Product Change Notification: P-20-019906

Micro K THT covers using BASF A3HG5 LS 23341 grade material.

Implementation of the usage of BASF A3HG5 LS 23341 grade for Micro K THT covers.

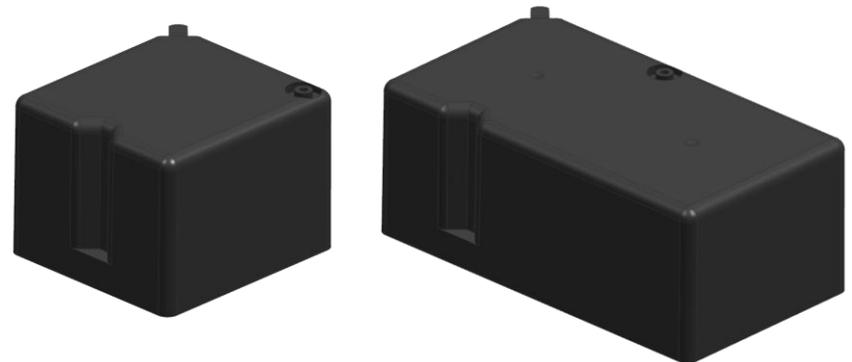
Status old:

Status new:

Material: PA6.6 GF 25%
Supplier: BASF
Supplier grade: Ultramid A3HG5 LS 23189

Material: PA6.6 GF 25%
Supplier: BASF
Supplier grade: Ultramid A3HG5 LS 23341
